# 2017 Corvette: GM TechLink: 3rd Gear Condition on Manual Transmission

## 3rd Gear Condition on Manual Transmission

**GM TechLink**

**November 23, 2016**

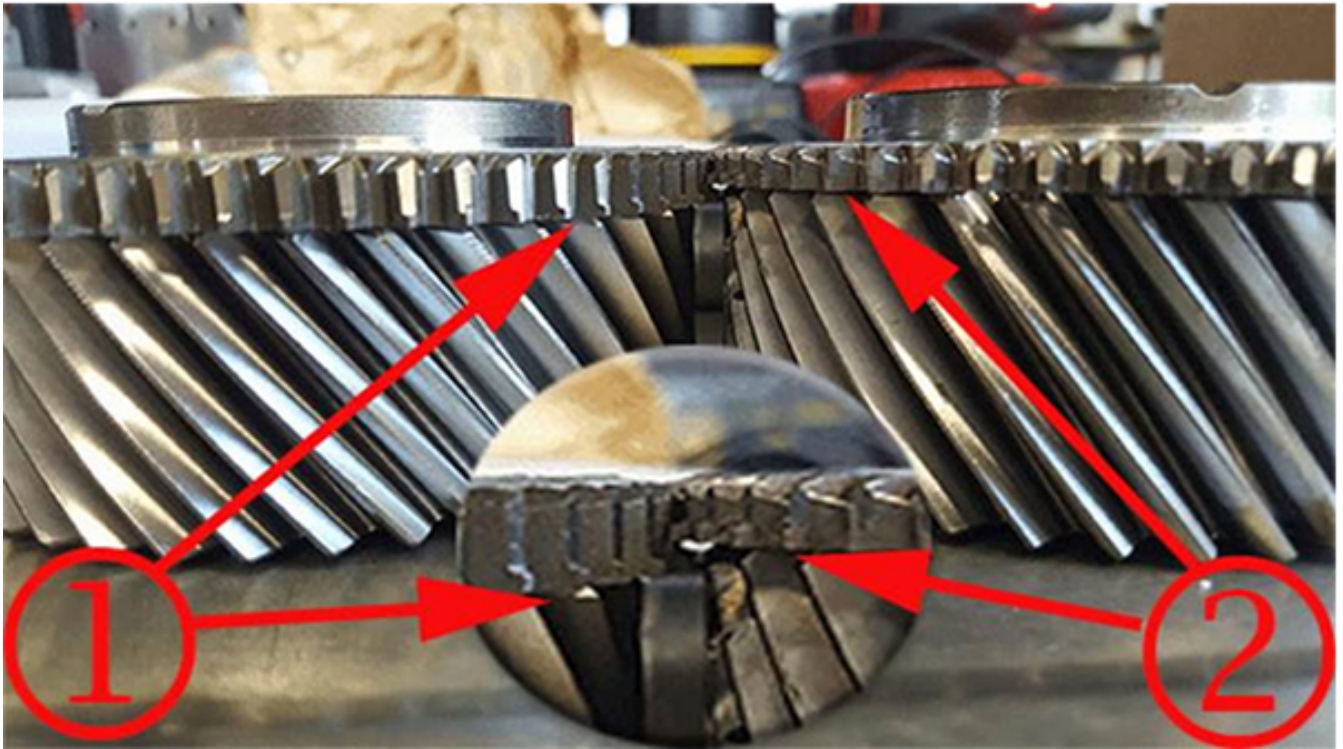
Some 2017 Camaro and ATS-V models equipped with a 6-speed transmission (RPO MM6, MG9) and 2017 Corvette models equipped with a 7-speed transmission (RPO MEP, MEK) may hop out of 3rd gear due to a mis-machined gear. These vehicles will have very low mileage or the condition may be noticed during PDI.

If the transmission does not hop out of 3rd gear, shift back to 2nd gear and repeat the shifting and accelerating procedure 10 times. If the transmission does not hop out of 3rd gear, the transmission has the correctly machined gear. (Fig. 14, #1) If the hop out of 3rd gear is verified, there is a mis-machined gear (Fig. 14, #2) and the 3rd speed gear, synchronizer and shift collar should be replaced.

To determine if the transmission is operating properly, shift to 1st gear and then 2nd gear as quickly as possible at a low or medium throttle. Next, shift to 3rd gear and release the shift lever, accelerating quickly to a medium or heavy throttle; then decelerate.
